Pratt & Whitney

REF: License No. 06-07522-02
Docket No. 03003796
Control No. 138547

Provided below are responses to requests for information (RFI) contained in a letter to Pratt & Whitney from Donna Janda, NRC Region 1, dated July 5, 2005.

Physio-Chemistry Lab at the Willgoos Turbine Laboratory, Final Status Survey

Wipe Survey and Direct Measurement Results from Ventilation System

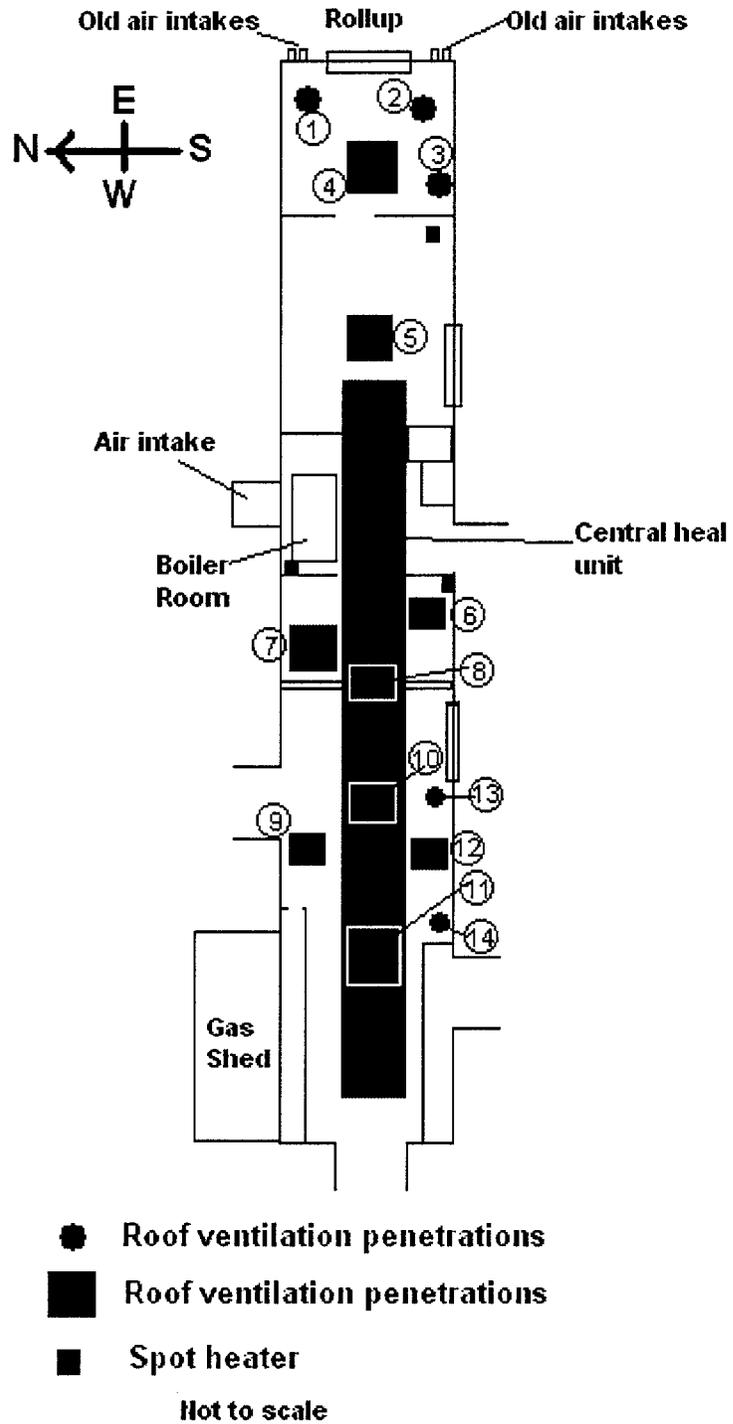
In response to the questions in the letter from NRC dated July 5, 2005, a close inspection of the building was performed on November 30, 2005. Ventilation ducts, floor drains and roof penetrations were located and are indicated on the drawings below.

a. Ventilation and Exhaust

The original building was ventilated in the warmer months by roof fans and louvers located along the peak of the roof. There is now central heating system ducting in the center of the overhead, along with three spot heaters. There are also a number of old roof penetrations, and possibly some of them were used as fume hood exhausts. There is no ducting remaining in the building that might have been connected to fume hoods. The central duct is currently used for the heating and cooling system. There are no fume hoods remaining. Wipes and direct surveys were made on all roof vents. All remaining vestiges of roof penetrations and all remaining ventilation louvers have been wipe tested and surveyed directly. No detectable radioactive material was found. Results of these measurements are contained in the table following the drawing. All direct measurements were made with a G-M pancake-type frisker (SE International Inspector, Ser. #06213, cal. due Feb. 14, 2006).

Wipe test results in the area of remaining ventilation components.

Wipe Survey Results from Floor Drains

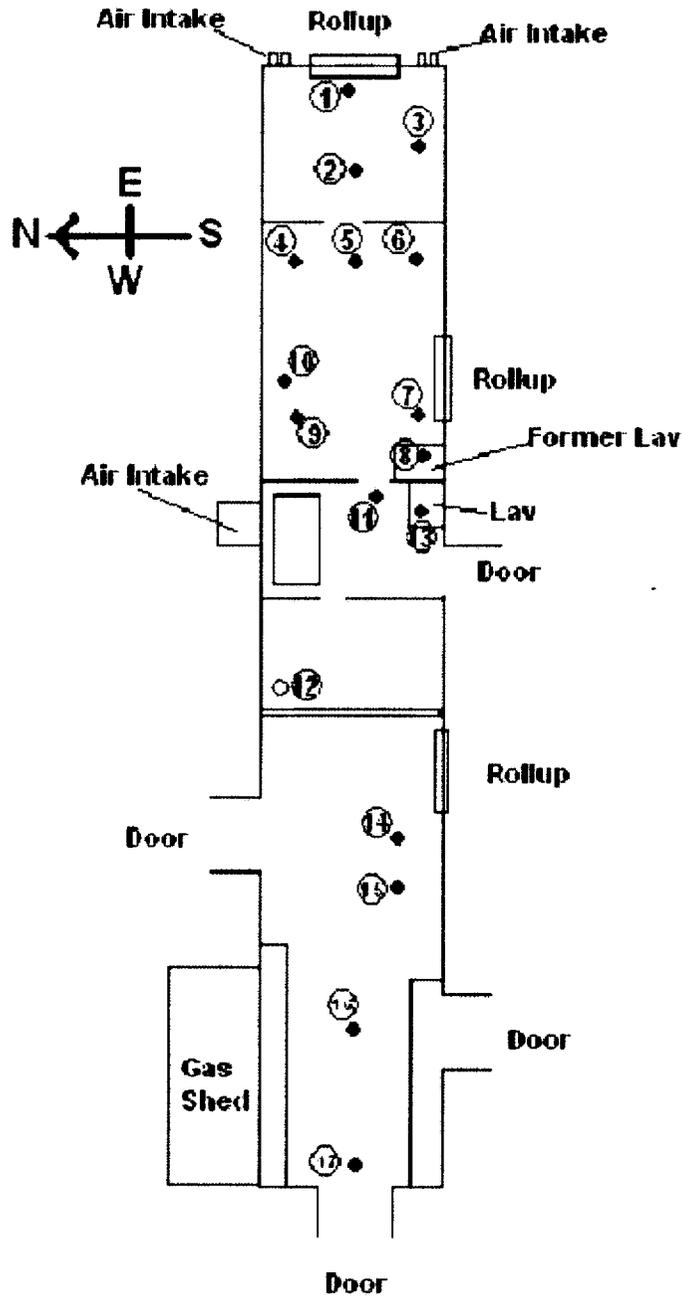
c. Floor Drains

During the close inspection of this building on November 30, 2005, 17 floor drains were located. There may be a few others that are hidden by the equipment and material stored inside this building. All of the floor drains are filled with concrete. This was a commitment made years ago between Pratt & Whitney and the U.S. EPA to prevent sewer discharge of oil and other chemicals. It is not feasible or ALARA to remove this concrete to perform a survey, especially since the C-14 used was in gaseous form and that no C-14 contamination was found anywhere else inside this building during the final radiological status survey. It is reasonable to assume that no C-14 is likely to have been discharged to the sewer.

- Floor drain plugged with concrete
 - Unblocked pipe stub
 - Threaded brass plug
- Not to scale.

Wipe test results in the area of the floor drains.
